REMARKS

--APPARATUS AND METHOD FOR ALIGNING VARIABLE-WIDTH
INSTRUCTIONS WITH A PREFETCH BUFFER--.

FIG. 3

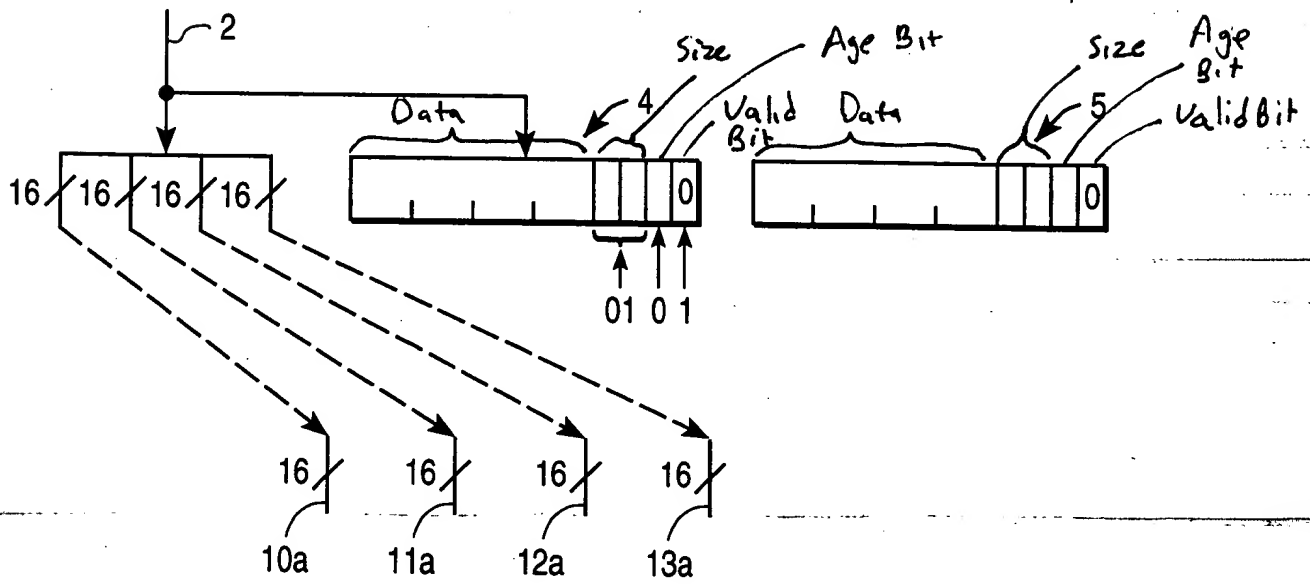
The Examiner objects to the drawings as failing to show steps. This is highly irregular. To the undersigned's knowledge, the "features" discussed by 37 CFR 1.83(a) refer to the structural features, not steps. Applicant requests clarification and asks that the Examiner verify that this is a proper objection, although additional drawings can be provided if the Examiner insists.

Please accept the amended Figures 3-5, in which changes to the drawing sheets are shown in red.

Figures 3-5 have been amended to add the labels as requested by the Examiner.
